IN THE MATTER A Notice of Requirement by
Wellington City Council to alter
Designation 58 (Moa Point
Drainage and Sewage
Treatment) to provide for the
construction, operation and
maintenance of the proposed
Sludge Minimisation Facility at
Moa Point, Wellington

JOINT WITNESS STATEMENT (PLANNING)

DATED 14 December 2022

ANNEXURE A – AGREED CONDITIONS

Title: PROPOSED ALTERATIONS TO DESIGNATION 58 BOUNDARY (POST CONSTRUCTION)

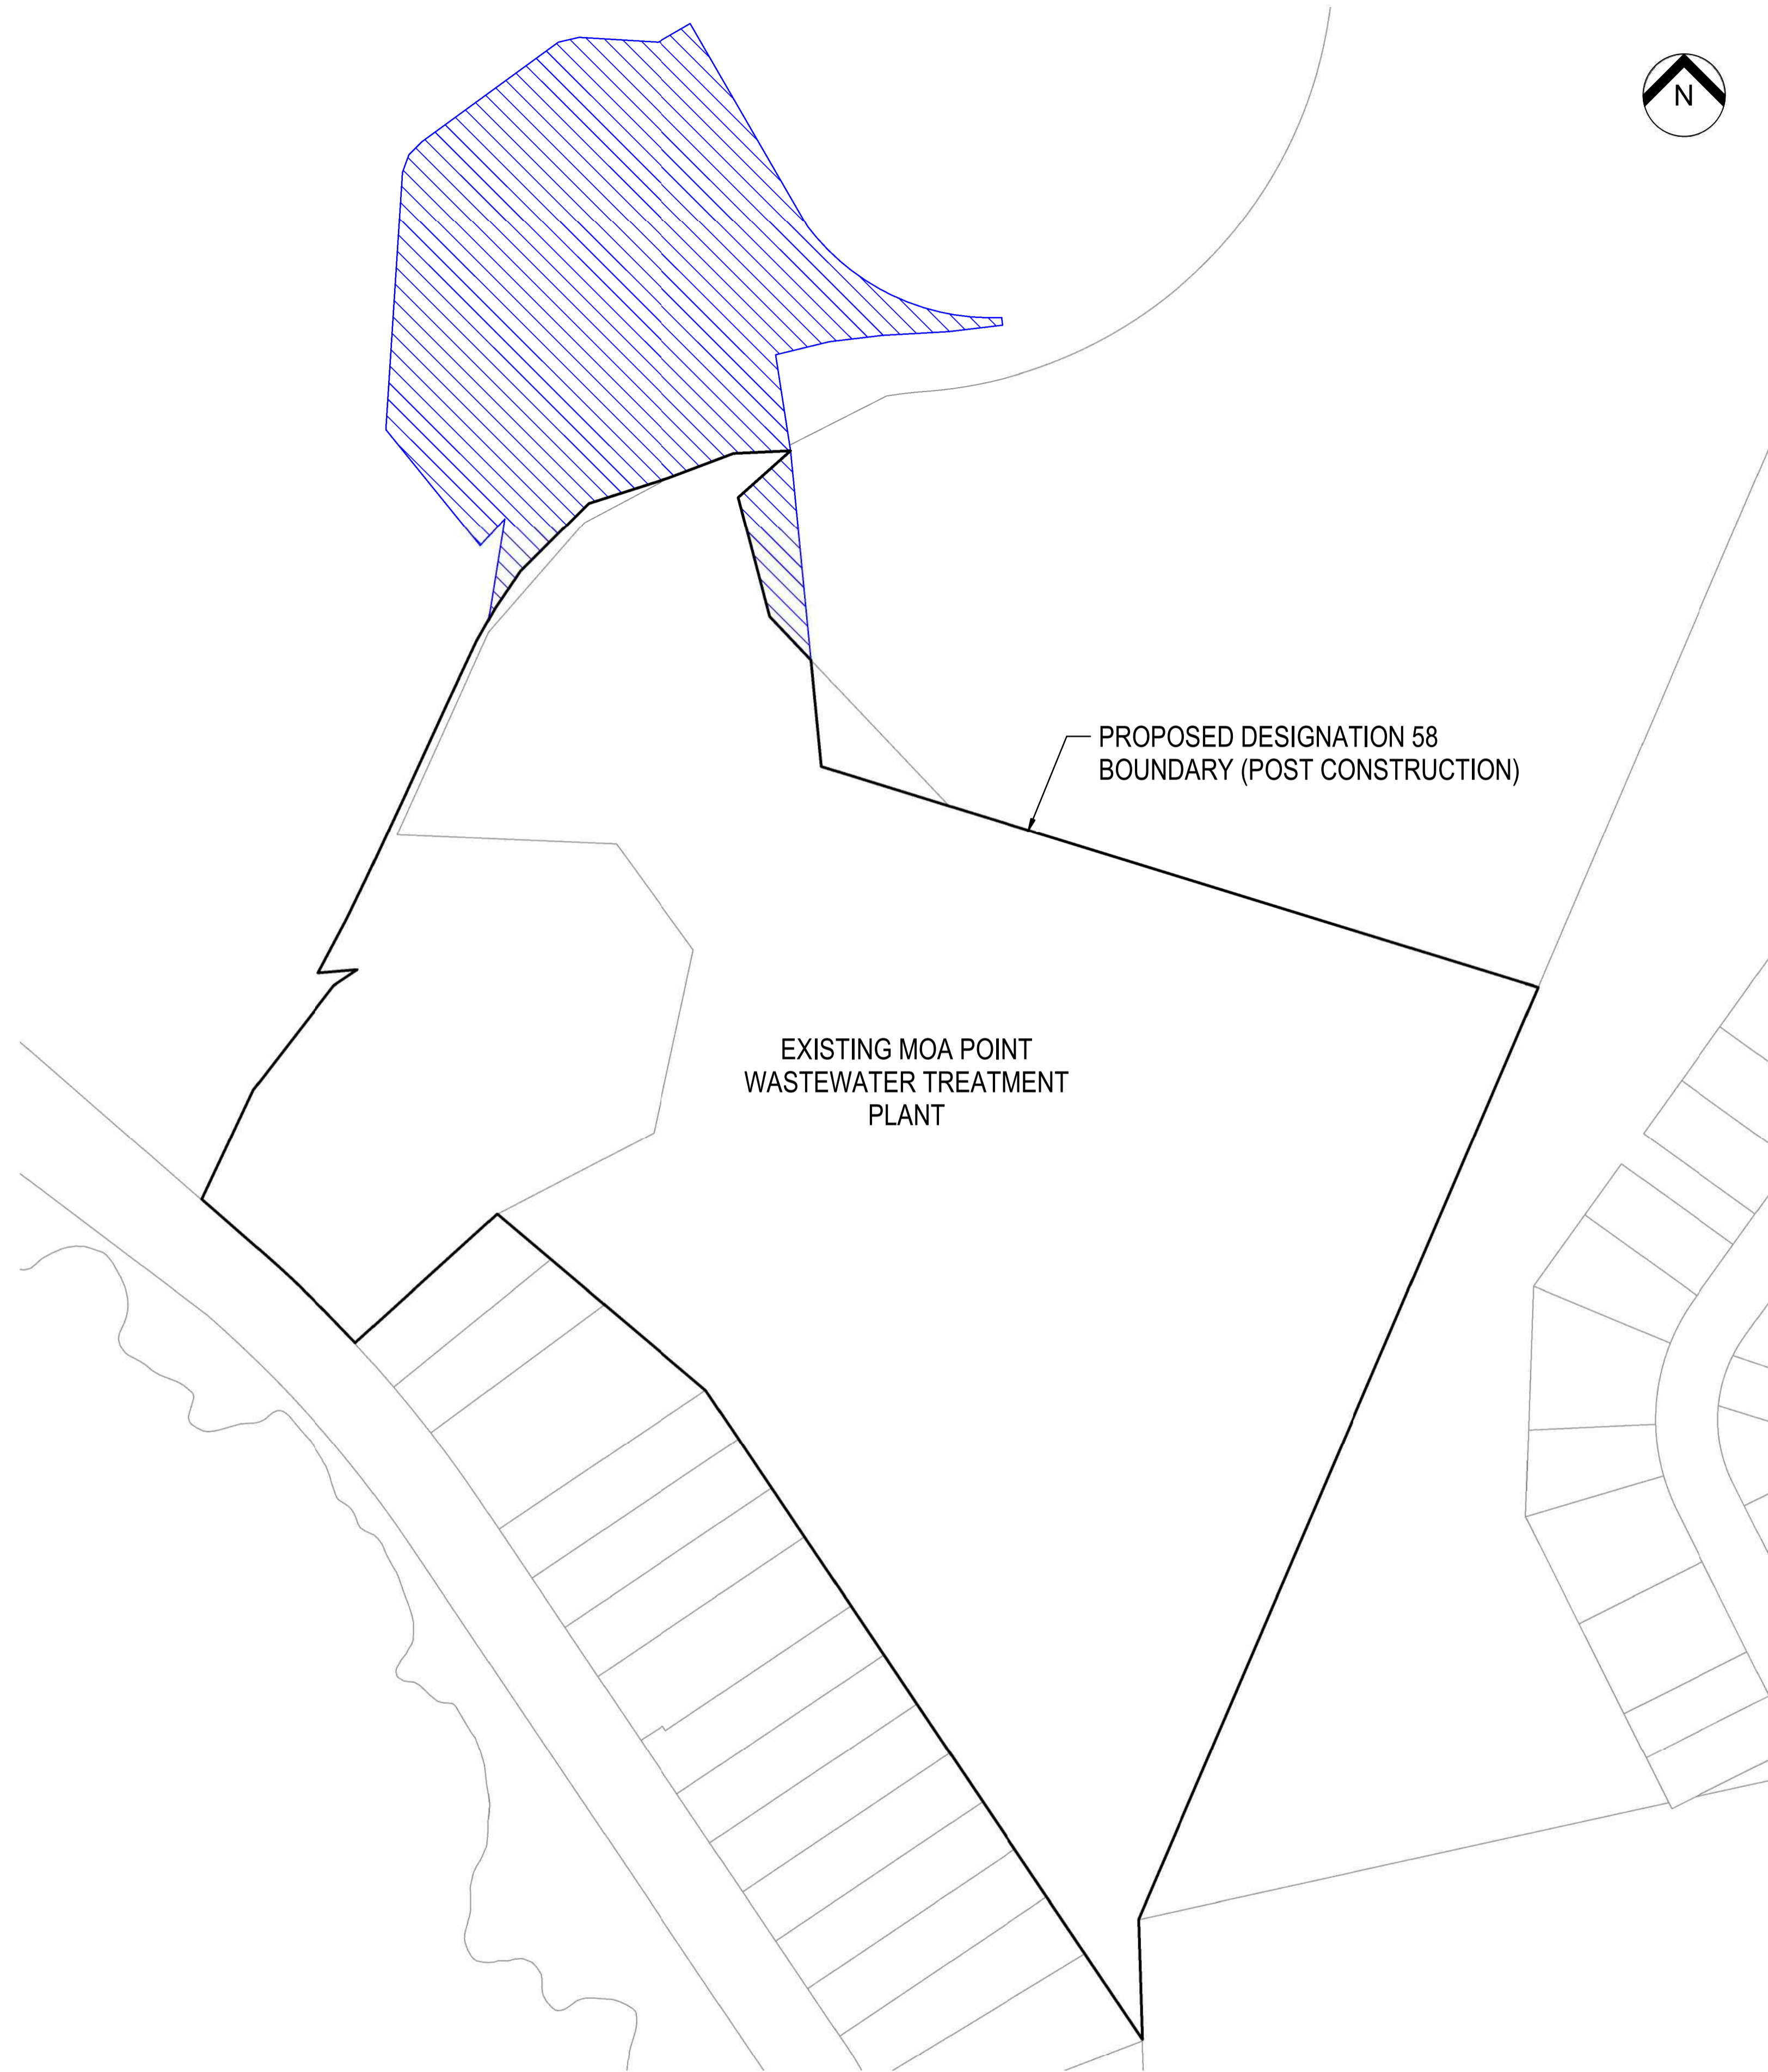
| | | Final conditions as agreed between Ms Zorn and Mr McGimpsey (Changes from wording proposed in supplementary evidence of Mr McGimpsey, and now agreed by Ms Zorn marked up in red/underline or strikethrough). | Additional comments |
|-------------------|--|---|---|
| 19.3 | | <p>As soon as reasonably practicable following the completion of construction of the SMF, the Requiring Authority shall give notice in accordance with section 182 of the RMA, seeking the revision of the designation boundary to that shown in Plan 3258521-DA-K0112 Rev A.</p> | |
